**Town of Henderson WD #1**
**12105 Town Barn Road**
**Henderson, New York 13650**
**RE: Town of Henderson WD #1**
**125,000 Gallon WSP**
**May 20, 2026**
**Dustin Clark**
**Town Engineer**
**(315) 938-7434**
**Job No. 324329**

# WATERSPHERE INSPECTION REPORT

JOB NO: 324329 INSPECTOR: Blake Collins (KW)

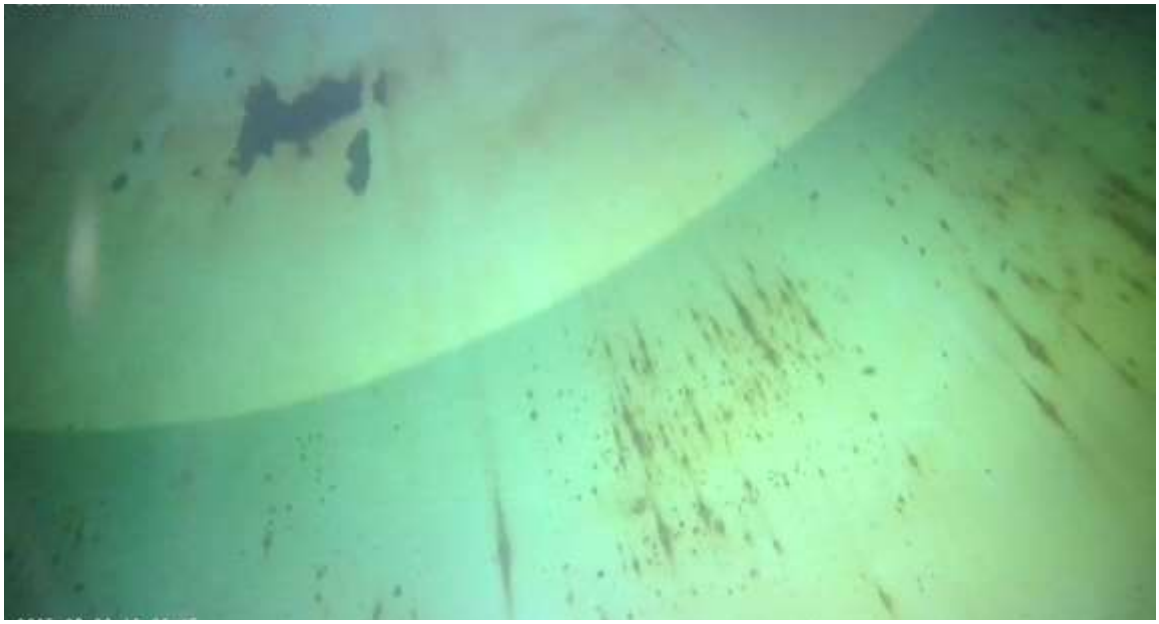
Photo shows sediment in the tank. Silt ingested into the sprinkler system can clog the sprinkler heads, rendering the system deficient. We recommend performing a dry interior cleanout to prevent damage to the sprinkler system.

**Due to slope in bottom of tank, a robotic in-service cleanout cannot be performed.**

Photos show the condition of the interior wet area coating system. We recommend abrasive blasting all rusted and abraded interior wet areas to SSPC-SP10 (near white), and brush blasting all remaining interior wet areas to SSPC-SP7; then applying one (1) spot coat of epoxy primer to all areas blasted to #10, stripe coating all weld seams, and applying an epoxy liner to the entire tank, to achieve 8 to 10 mils of total dry film thickness. Total mil thickness will include a combination of the existing and new coating.
